RENEA'S SECOND ADDITION TO JACKSON STREET

Engineering Comments: FINAL PLAT COMMENTS (should be addressed prior to submitting the FINAL PLAT for acceptance and signature by the City Engineer):

The plat illustrates the proposed 2-lot, 0.6± acre subdivision which is located on the Northeast corner of State Street and North Claiborne Street, within Council District 2. The applicant states that the subdivision is served by city water and sanitary sewer systems. The purpose of this application is to create 2 legal lots of record from 2 metes and bounds parcels and 1 legal lot of record.

DETAIL SITE PLAN

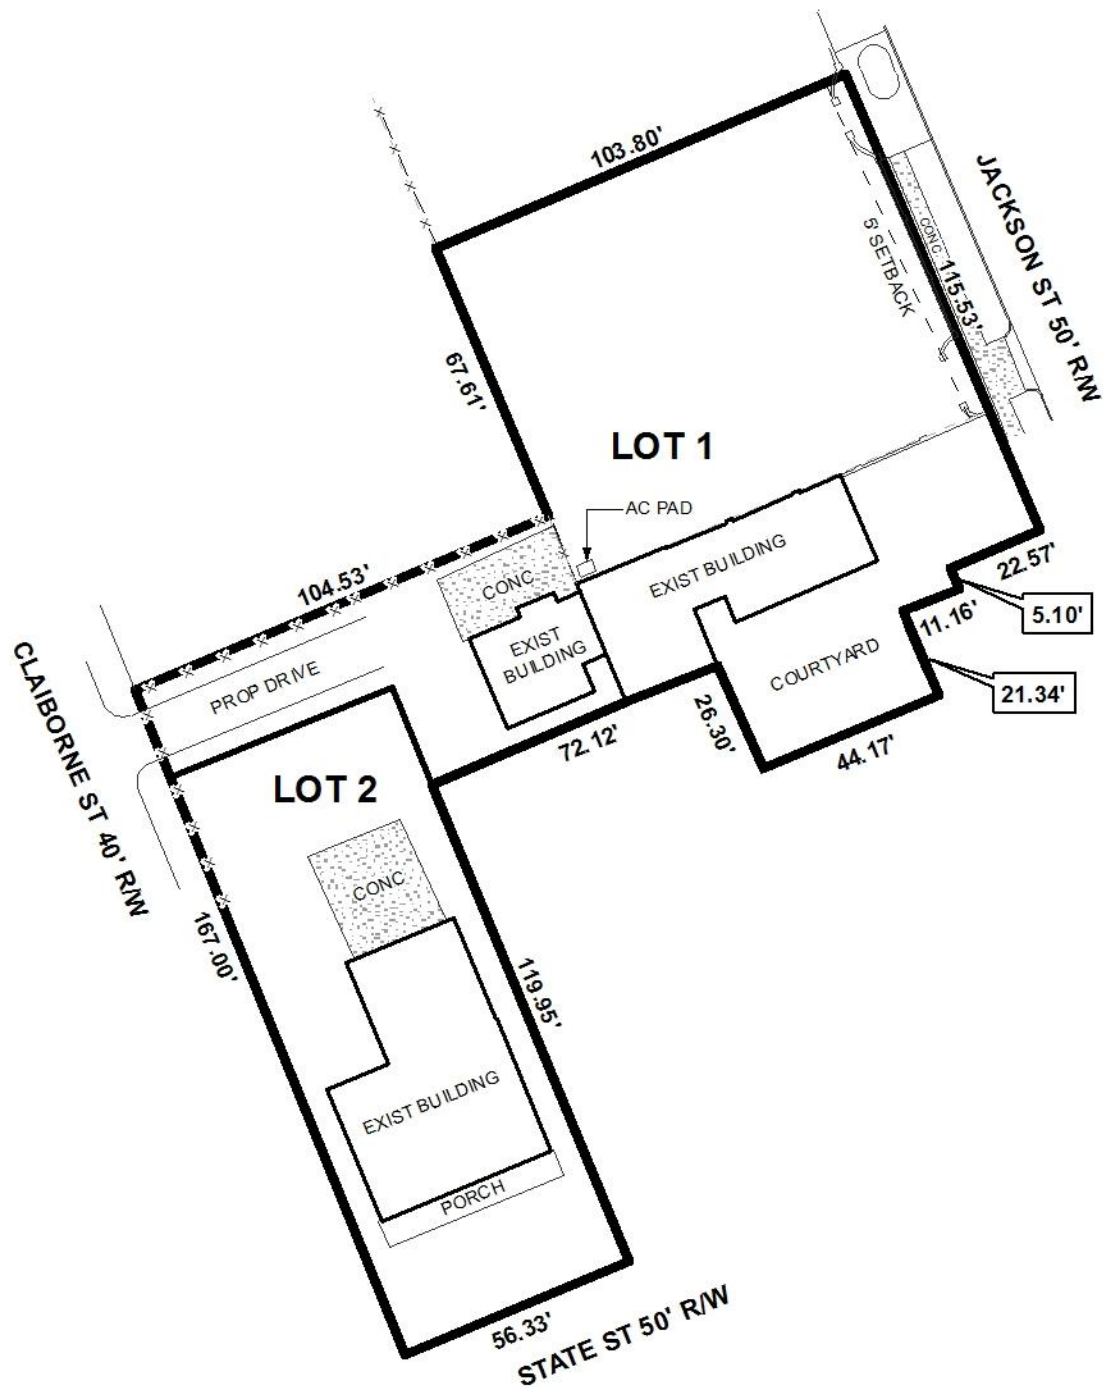
- B. Provide information showing the limits and boundary of LOT 1 and 2.
- C. Review and revise the written legal description to match the written bearings and distances. Many labels are too small to read.

- D. Dedicate the corner radius (25' minimum or as approved by the City Engineer and Traffic Engineer) at the Southwest corner of LOT 2.
- E. Show and label all flood zones.

Property width requirements for a T-4, Mixed-Use, Low-Intensity Sub-District, are a minimum of 18' and a maximum of 120' per Section 64-3.I.8.(b).2 of the Zoning Ordinance. The property width is illustrated on the preliminary plat as 115'± for proposed Lot 1 on North Jackson Street, and 22 feet along North Claiborne Street. Lot 2 will have ±56' of street frontage on State Street and ±145' of frontage on North Claiborne Street and if approved, should be retained on the Final Plat.

A 5-foot minimum building setback line is depicted on the preliminary plat along Jackson Street. The DDD, per Section 64-4.I.8.(d), allows from 0' minimum -12' maximum setback along all street frontages. If approved, the Final Plat should be revised to illustrate a 12' maximum building setback line along Jackson Street, Claiborne Street and State Street, with a note stating a 0' minimum is allowed.

The DDD requires 20' parking setback in T-4 Sub-districts per Section 64-3.I.8.(d) of the Zoning Ordinance. If approved, placement of a note on the Final Plat indicating that any parking will be 20' from the street property line will be required.

There is a 10' driveway width requirement within front setback along primary frontages within T-4 Sub-districts, per Section 64-3.I.11.(c)(3) of the Zoning Ordinance. The preliminary plat illustrates the driveway as being 13' in width. If approved, the driveway width should be revised to indicate a maximum of 10' on the Final Plat.

- 1) Revision of building setbacks to reflect a maximum building setback line of 12' along all streets;
- 2) Placement of a note stating that a 0' minimum building setback is allowed;

- 3) Placement of a note stating that parking must be setback 20' from the property line;
- 4) Revision of driveway width along Claiborne Street to allow a maximum pavement width of 10';

- 5) Retention of the lot size information on the Final Plat to be depicted in square feet and in acres;
- 6) Placement of a note on the Final Plat stating that each proposed lot is limited to one curb cut each per street frontage, with any changes in the size, design and location to be approved by Traffic Engineering and conform to AASHTO standards.
